# Memorandum

Responses to Comments on the 1090 S. De Anza Boulevard Hotel Project IS-MND

Subject 1090 S. De Anza Boulevard Hotel Project Initial Study and Mitigated Negative

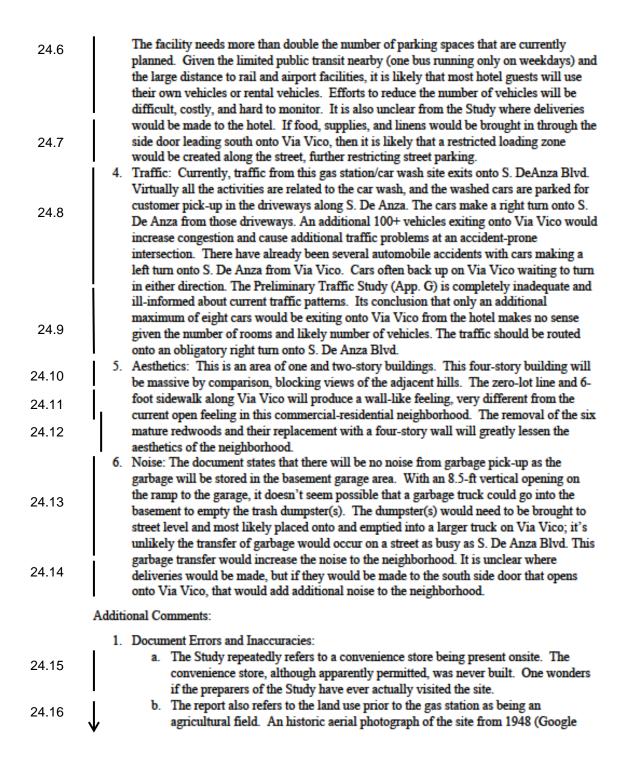
Height: The proposed height is 55 feet and 3 inches, with a 61-foot height at the proposed tower. This height exceeds the height limit of 50 feet for areas zoned CP (San Jose Municipal Code Table 20-100). An exemption is made for Urban Villages with an approved Urban Village Plan. No Urban Village Plan has been approved for the South De Anza corridor so the 50-foot limit applies. Furthermore, there are no buildings that high along the San Jose City portion of South De Anza Boulevard. The maximum number of stories is two, even for very recent construction. The two-story maximum also applies to the other street affected by this proposed project, Via Vico. Allowing a fourstory building that exceeds the height limit, without the planning process and community participation that goes into the development of an Urban Village Plan, would appear to violate the City's own planning/zoning documents. The South De Anza corridor is part of the Horizon III Urban Village Development. The only Horizon III Urban Village with an Urban Village Plan is the 24th and Williams Urban Village. That Urban Village has height limits ranging from 30 feet to 65 feet. Since it is unknown what height limits will be established for the South De Anza Urban Village, it is premature to build a structure exceeding the current zoning since a lower height limit could be determined for this part of the future Urban Village.

24.2	The proposed height is 55 feet and 3 inches, with a 61-foot height at the proposed tower. This height exceeds the height limit of 50 feet for areas zoned CP (San Jose Municipal Code Table 20-100). An exemption is made for Urban Villages with an approved Urban Village Plan. No Urban Village Plan has been approved for the South De Anza corridor so the 50-foot limit applies. Furthermore, there are no buildings that high along the San Jose City portion of South De Anza Boulevard. The maximum number of stories is two, even for very recent construction. The two-story maximum also applies to the other street affected by this proposed project, Via Vico. Allowing a four story building that exceeds the	The project's consistency with the City's Municipal Code and General Plan is discussed in Section 10, Land Use and Planning of the Draft IS-MND. As discussed there, impacts related to this topic would be less than significant. The proposed project would exceed the established height of the Commercial Pedestrian (CP) zone of 50 feet, as it is located in a geographic area that is subject to specific height restrictions. Per Section 20.85.020(E) of the San José Municipal Code, properties identified on the general plan land use diagram in an urban village area boundary, and have a neighborhood/community commercial designation shall not exceed 120 feet and therefore abides by the Geographic Area
